service bulletin

No. 88-15

- A. V6 Oil Injection Pumps P/N 41032 & 41033
- B. Throttle Lever and Linkage Wave Washer Removal Models 70-75-80-90-100
- C. Merc 4 & 5 & 102cc Sail Power Field Service Kit (Temperature Control) Part No. 813142A1
- A. V6 OIL INJECTION PUMPS P/N 41032 & 41033

Figure 2.

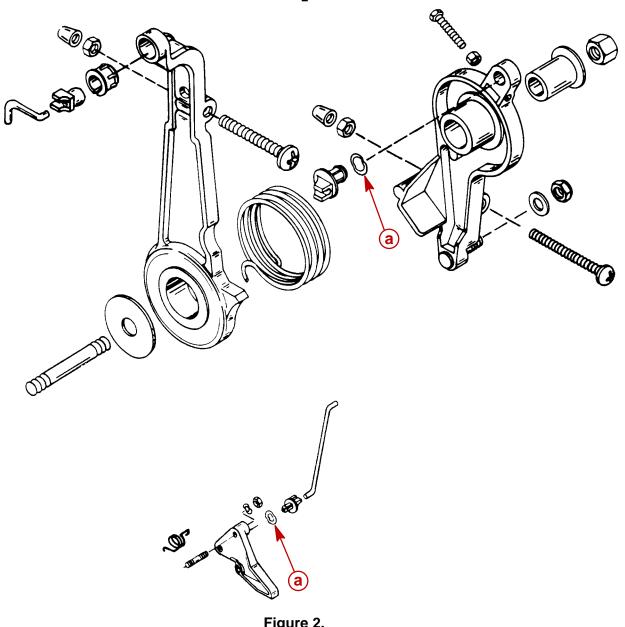
When servicing 3 cylinder model 70-75-80-30 and 4 cylinder 100 HP outboards for any reason, remove the wave washers from the swivel bushings. Figure 2. Removal of the wave washers will prevent the swivels from breaking during removal, installation. Future production outboards will have the wave washers removed.

a - Remove
